COTTAM SOLAR - Deadline 1 – 17 October 2023

Part 2 - APPENDIX 2 – Hedgerows/Views - Photographs/Photography raised at Open Floor Hearing Oral submission – Tuesday 5th September 2023.

ENVIRONMENTAL STATEMENT APPENDIX 8.1.5: PHOTOGRAPHY AND PHOTOMONTAGE METHODOLOGY PART 1 OF 5 January 2023

Viewpoint 9 - single frame 50mm image (Summer) view left of the same location as the (Winter) view on the right.

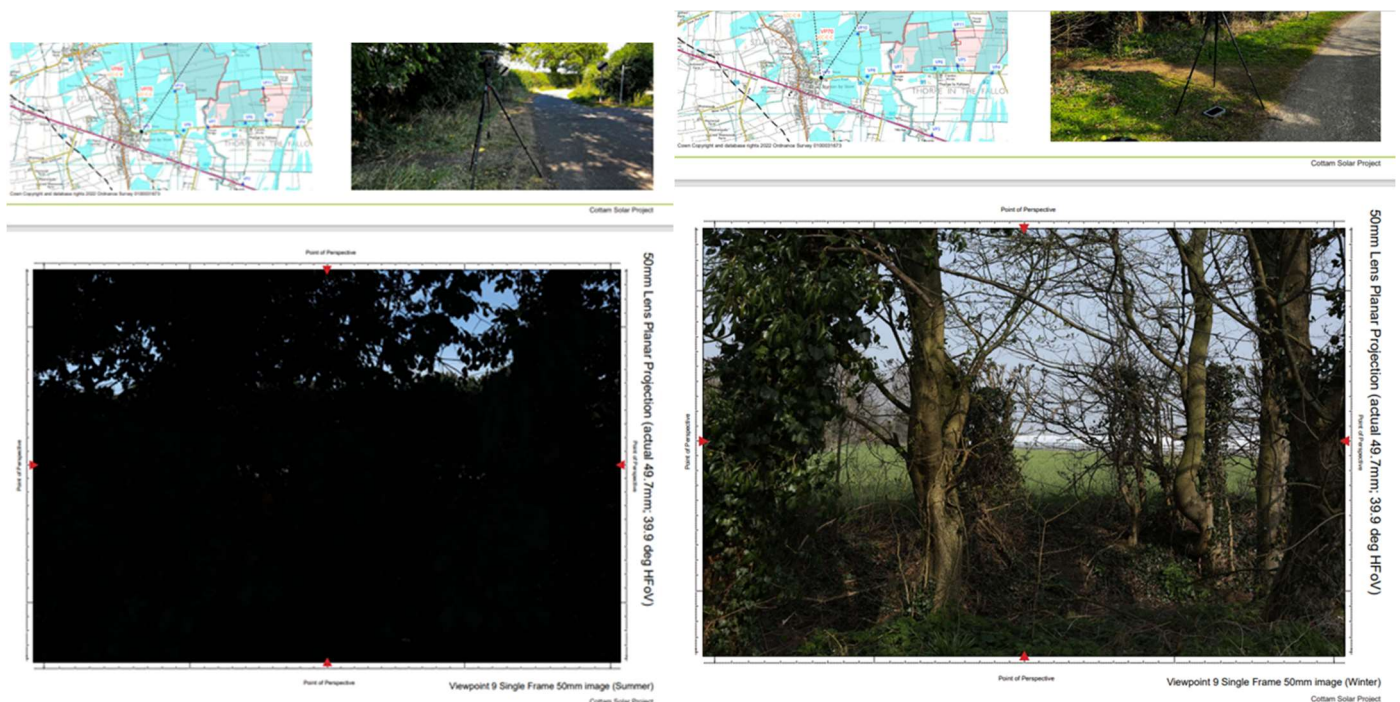
It is impossible to know if the summer photographers image above contained in Methodology Part 1 of 5 page 1 was taken at the same location as the Winter image (Viewpoint 9) as none of the three trees are visible in that summer image, compared to the writer's image below also taken on a sunny day on 25 September 2023 at the exact location as the Winter image above.

The writer knows this area incredibly well and I cannot see the logic of why the images at page 1 above are in the Environmental Statement Appendix. It makes no sense to take a photograph, through the native hedgerow, of the white plastic bio-mass crop storage structure, which was in the next field and temporarily blocking the view of the extensive landscape beyond and which the PRow (public footpath) through farmland (Viewpoint 10) can be seen ? **WHY ?** This 'storage facility' is no longer there as can be seen from the writer's own Summer image taken 25th September 2023 below. Please refer to the original images contained in the Environmental Statement Appendix above for enlargements of the 'Lanpro' photographer's original images.

Cottam 1 3D Model (Infrastructure) on 2m LIDAR DTM data (OSGB36)

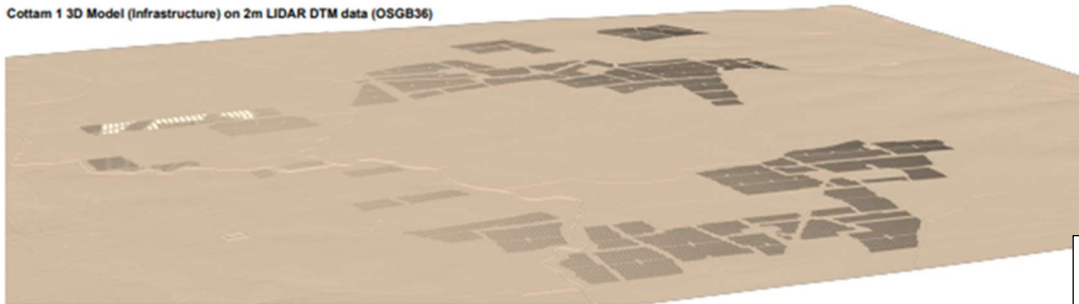
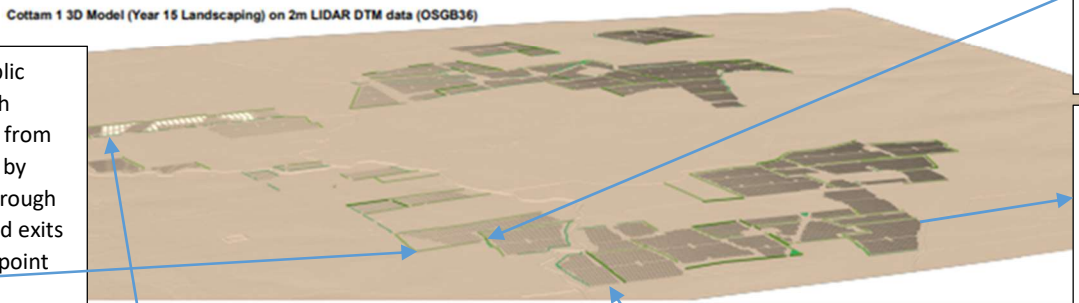
The two models above are from Cottam Solar Scheme and show the extent of the solar arrays and landscape (hedge planting) at Year 1 and Year 15.

**How is it possible to demonstrate a planting scheme above which *in effect is showing the whole of the solar site with no growth visible at all at Year 1 Landscaping above unless all the hedges have been removed in the first instance - surely some of the hedgerows will remain in situ ? I cannot see any hedgerows at all in Year 1 despite increasing the topography 3D image on page 11 several hundred percent. And, in Year 15, it would seem that the hedgerows in that landscape are all now shown in situ and growing so how would Cottam know where to plant the hedges shown in the 3D model as there are no images of the hedges / trees currently in situ on the land today shown on a similar map with which anyone can make comparisons ?***

I have found it incredibly difficult to understand the logic of the 3D topography ‘maps’ above demonstrating hedgerow growth at Year 1 and Year 15 based on my comments above.

Viewpoint 8 – Summer and Winter Environmental Statement 1 – 5

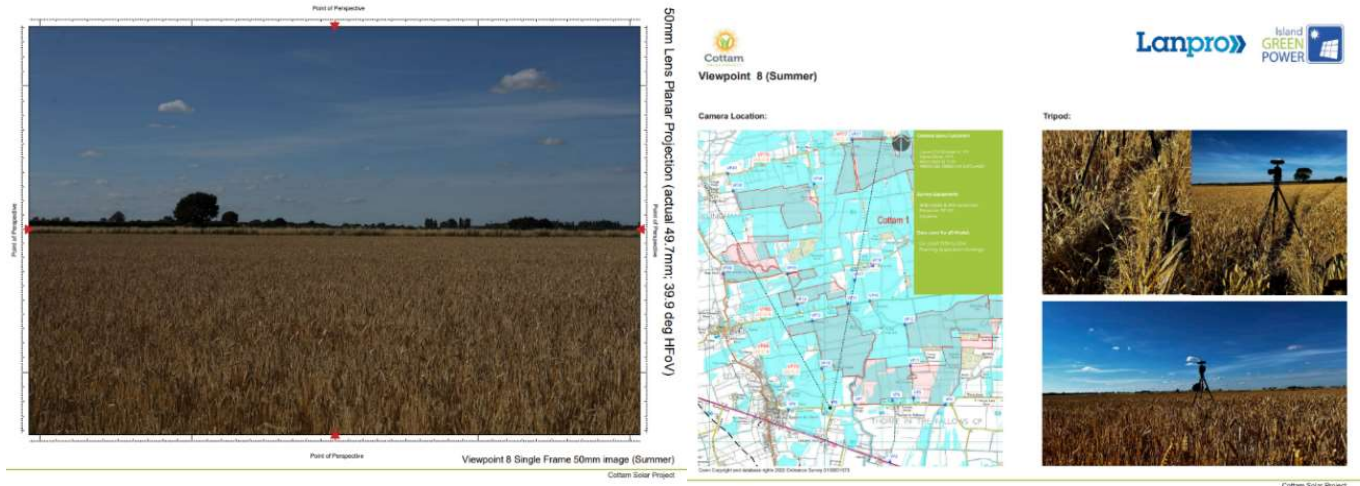
Although there is a PRoW (public footpath) across the field where the 'Lanpro' photographer took the Winter and Summer images above there is no public footpath sign in any of these images to indicate this nor, **WHY**, more importantly, *although the Cottages fall well within the angle of Viewpoint 8, they were not fully acknowledged and instead pushed to the extremities of the image and they could only be determined by increasing the image in the Environmental Statement referred to on page 1 on my screen by 6 fold and still difficult to see if you didn't know about them in the first instance.* They are not visible otherwise to the naked eye on the original image. These cottages are a particularly important feature along Fleets Lane and on the landscape (1) because they stand out and (2) they will be surrounded to all sides and rear by 4.5m solar panels, nor are they acknowledged at Viewpoint 10 ? ! I know the area well and again have taken my own images, 9, and 10 on pages 15, 17 & 19 to illustrate they exist.

Expanded image below from earlier Viewpoint 6 – see comments on page11 of this submission.

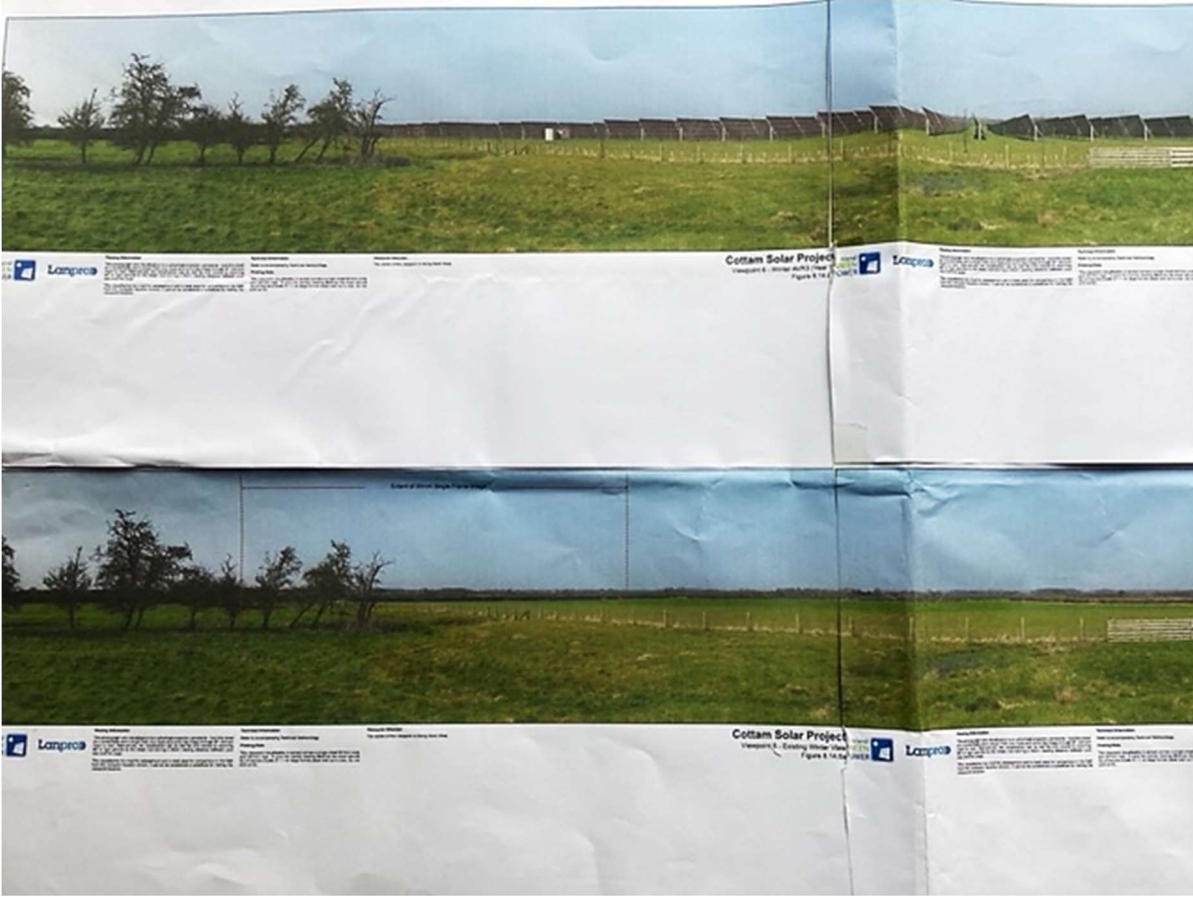
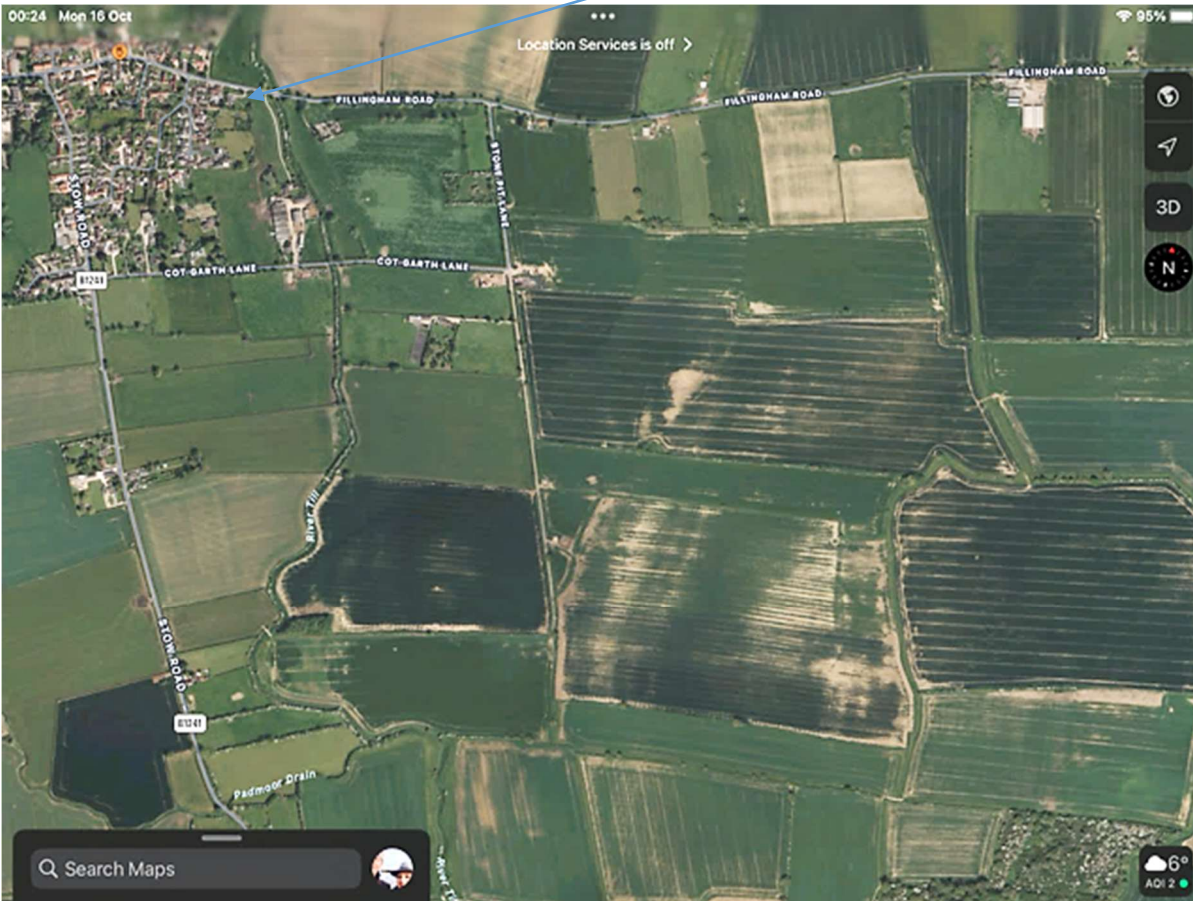
**Viewpoint 6** - The image opposite is part of the Environmental Statement of packages of Photographs taken *in one of the fields at Viewpoint 6 at the medieval hamlet of Thorpe le Fallows on Thorpe Lane*. It illustrates a 'before and after' the installation of the 4.5m tracking solar panels. It is such a small image I have copied from the original that it is difficult to see the scale of the solar panels that are in this photomontage but it is clear to see the wide open landscape 'before' view is a wonderful vista and 'after' view is horrendous. A larger version can be seen at the end of this document but the reader must view it in the Environmental Statement Photography/Photomontage document it appears. There is no indication in the writers submission as to scale of the solar panels in the landscape, nor any clear images of associated hardware, including security fencing and cameras the cameras being considerably taller than the panels. It is understood the solar panels will be 4.5m tracking.
